## ADDENDUM

Date February 2, 2024

Re Addendum No. 3 to the Construction Documents for:

Dorthea Dix Psychiatric Campus  
Pooler Pavilion Abatement  
Bangor, Maine  
Project No. 23134

A05-2

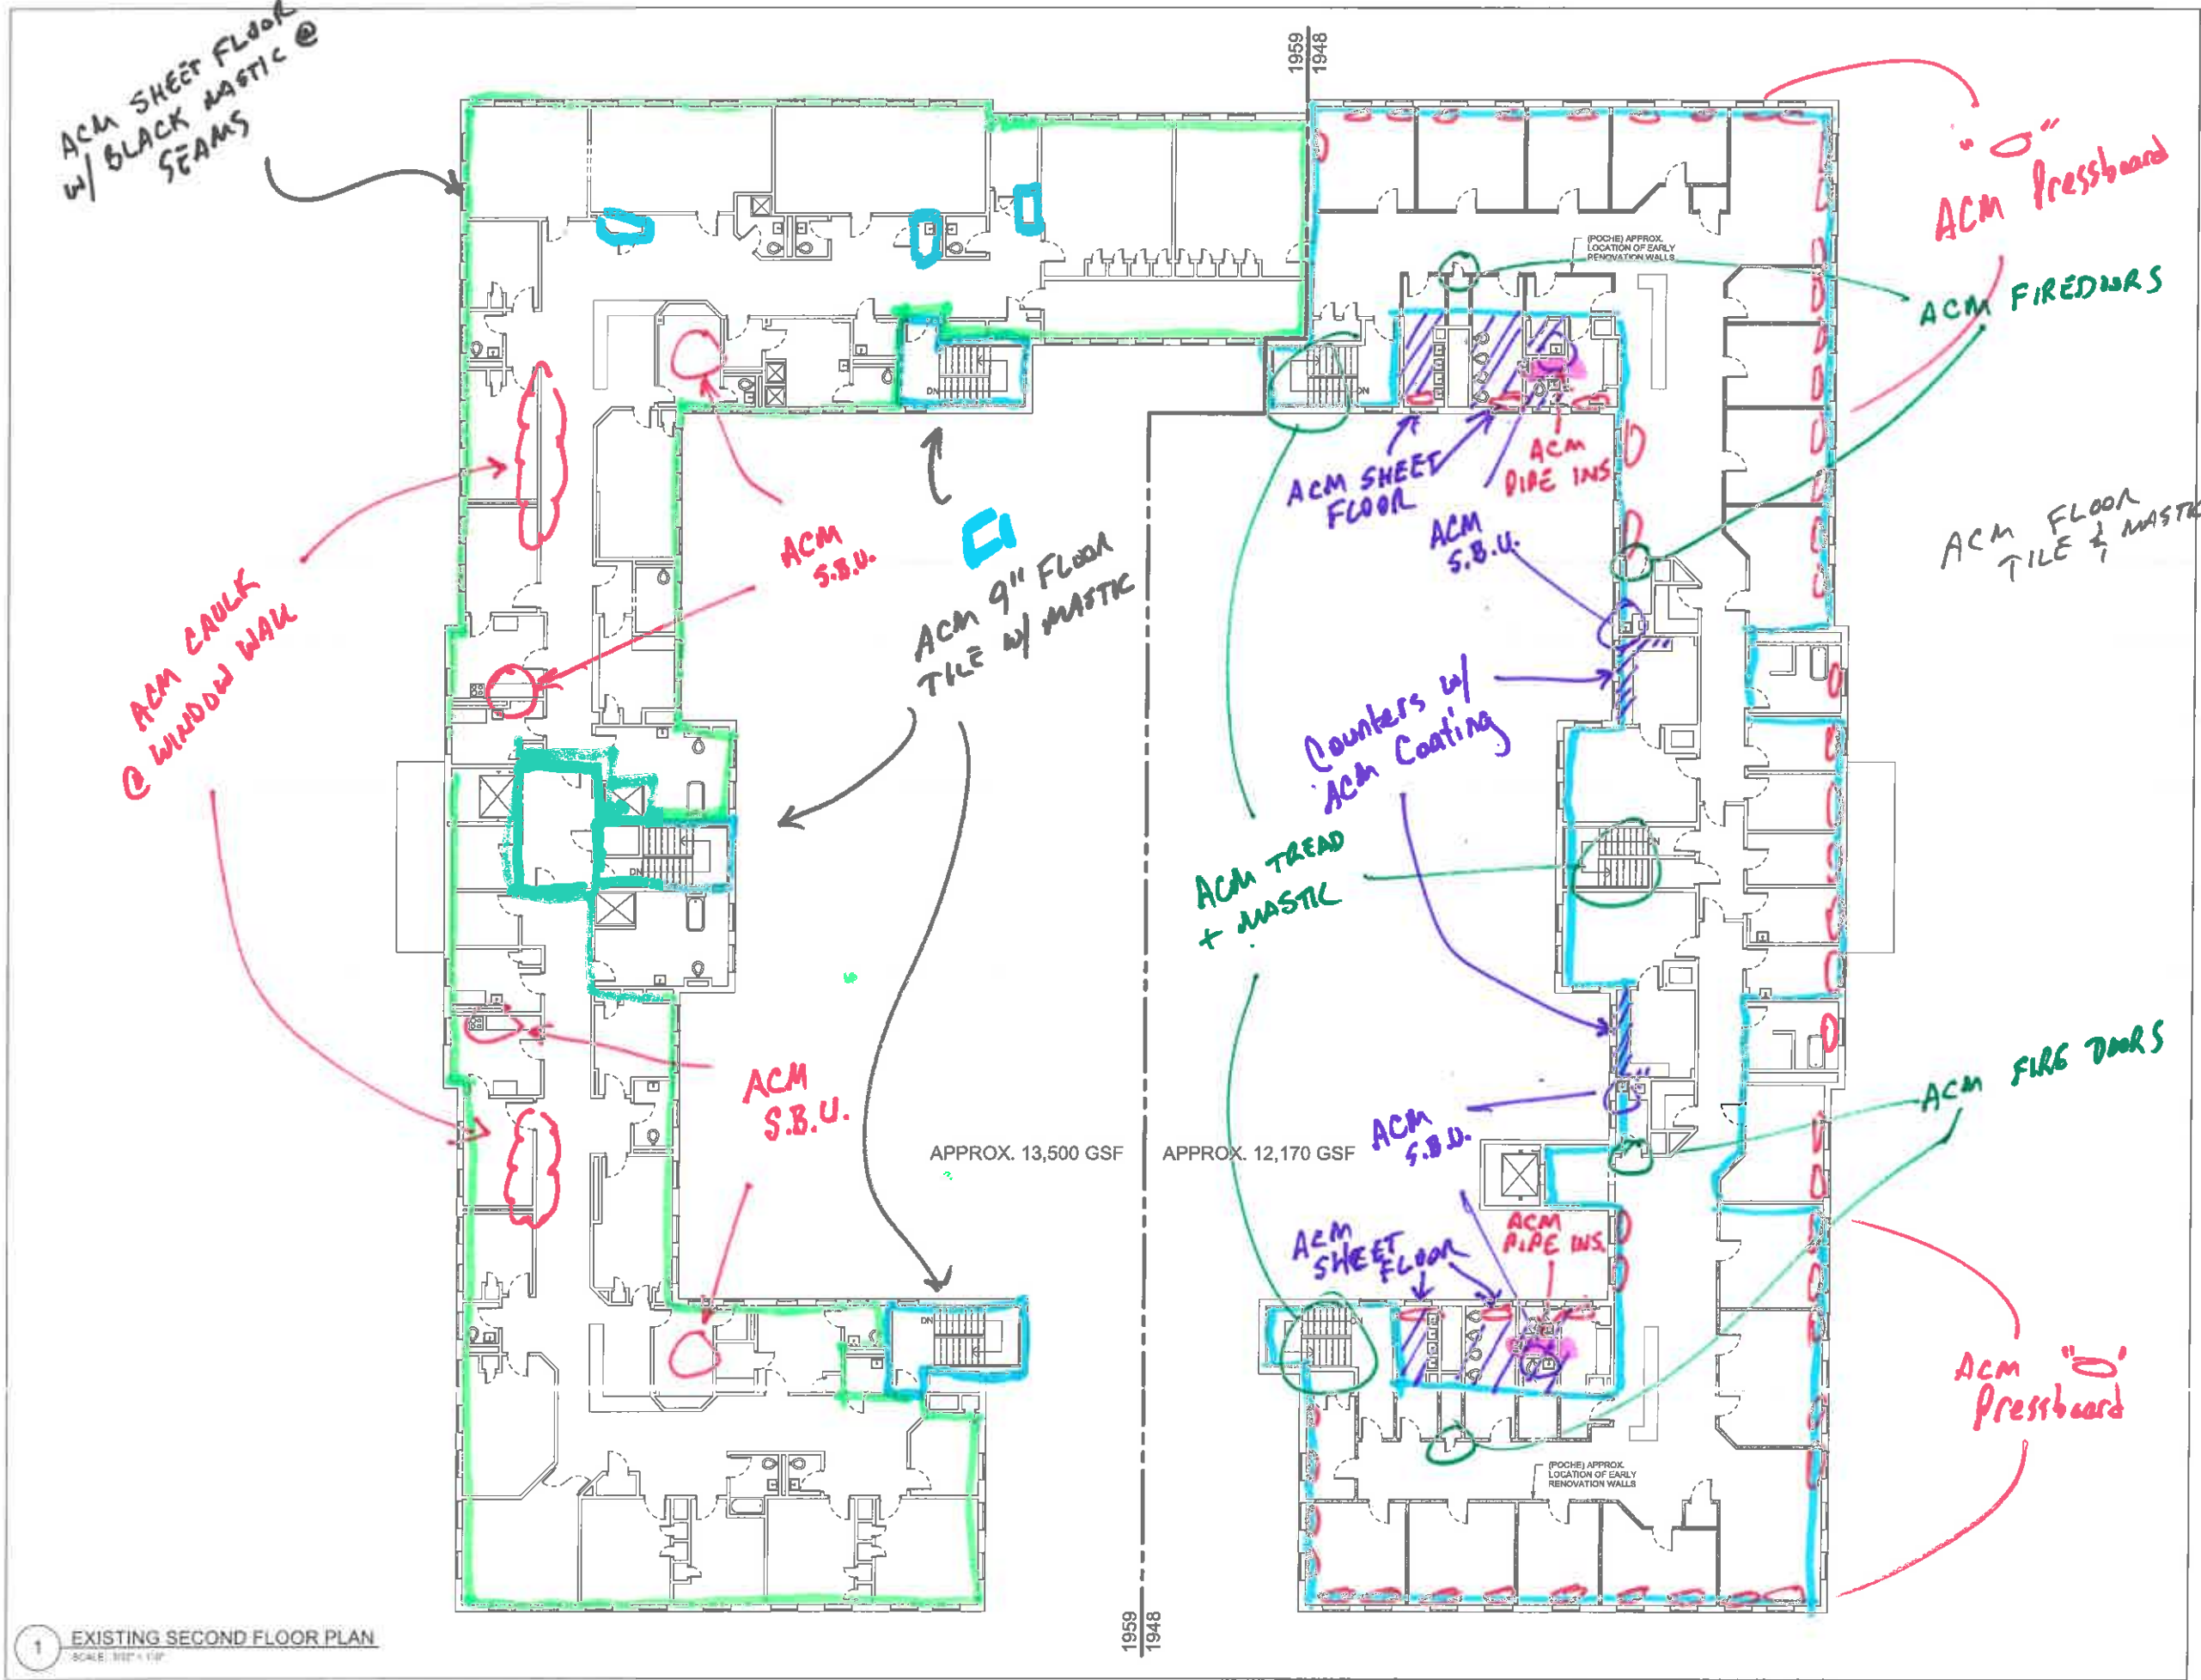
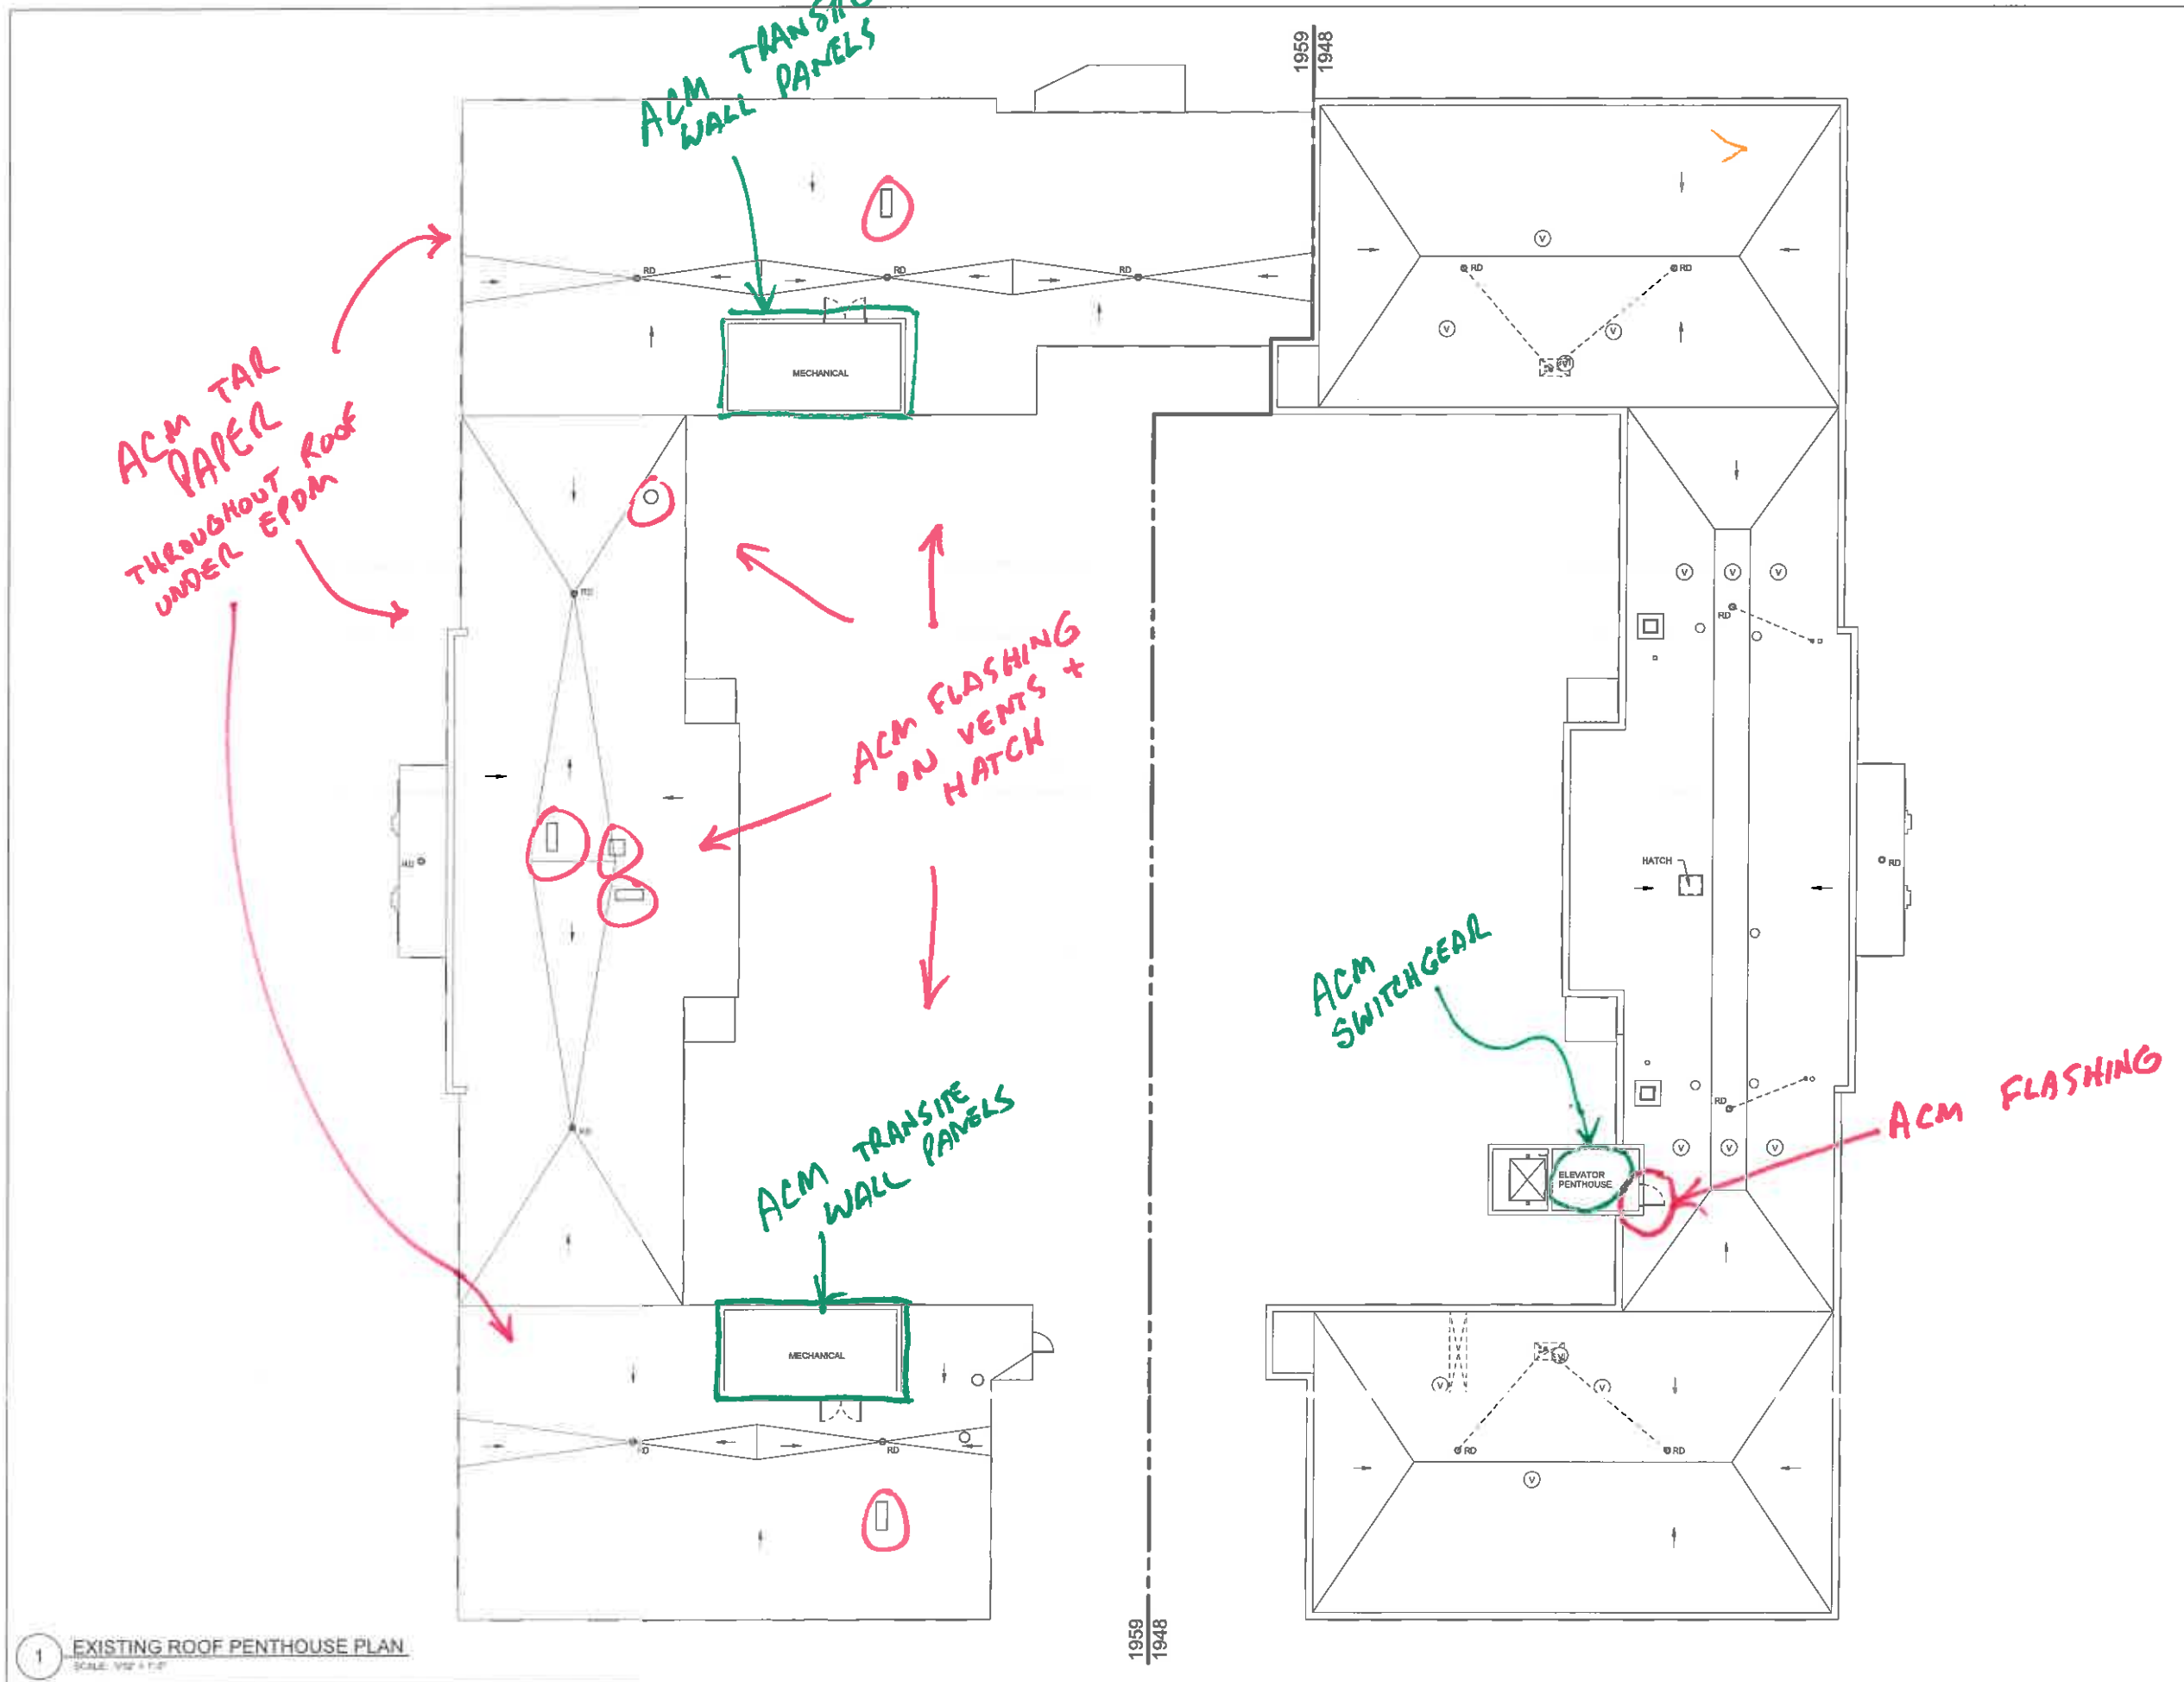
Q2: The RPF survey provides a summary of ACM to be removed called Table 1. Can you please provide a floorplan clearly identifying the locations of these asbestos containing materials?

Q3: At the prebid conference it was apparent a significant amount of interior walls have been built atop the asbestos containing flooring. Will you provide bidders with a way to quantify the amount of walls to be demolished to perform the asbestos abatement work?

Q4: At the prebid conference it was apparent a significant amount of asbestos flooring is present below other non-asbestos carpet or non-asbestos VCT tile. In some cases the asbestos layer is the bottom of three layers. Will you provide bidders with a way to quantify which flooring areas are single layer, double layer, and triple layer flooring?

Q9: Can a color-coded diagram of the floor surfaces requiring abatement be provided? OR shall the abatement contractor assume all floor mastics must be removed?

- Q28: What is the extent of the asbestos pipe insulation located within the building? There appears to be greater than 2,500 LF of pipe inside the new building.

**A2: See attached floor plan documents issued for reference with this Addendum.**

**A3: See attached floor plan documents issued for reference with this Addendum. The walls noted are approximate locations and quantities.**

**A4: See attached floor plan documents issued for reference with this Addendum. Much of the ACBM flooring is exposed and not covered by other flooring. The bidders have had the opportunity to see the areas of abatement and make determinations of what ACBM may be covered. Quantification of materials is the responsibility of the bidder.**

**A9: See attached floor plan documents issued for reference with this Addendum.**

**A28: See attached floor plan documents issued for reference with this Addendum.**
- Q29: In an effort to eliminate a change order to the State of Maine, will the abatement contractor own all demolition to access and removal and disposal of all floor finishes, mastics, & pipe insulation located above grade within the building?
